## 1 Products affected

## 2 Type of change

| Product Change Notification |               |              |             |              | PCN DFKH-31 Terminal pins changed |        |             |

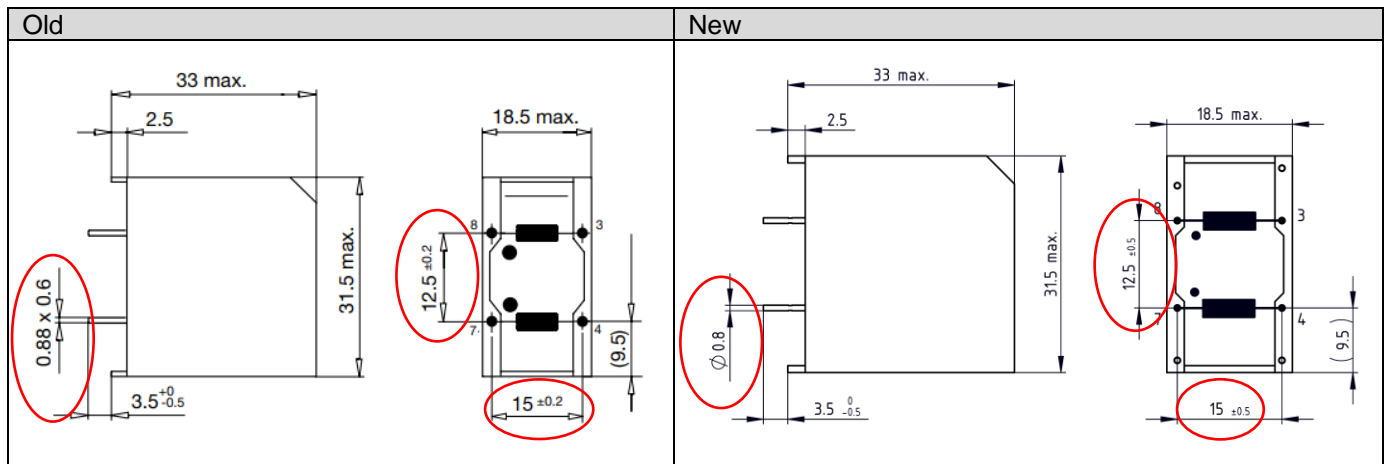
- Terminal pins changed

- Rectangular pins substituted with round pins

- Standardization of choke cases
- Optimize assembly process

| Form          | Yes | Check PCB pin hole dimension and tolerances |
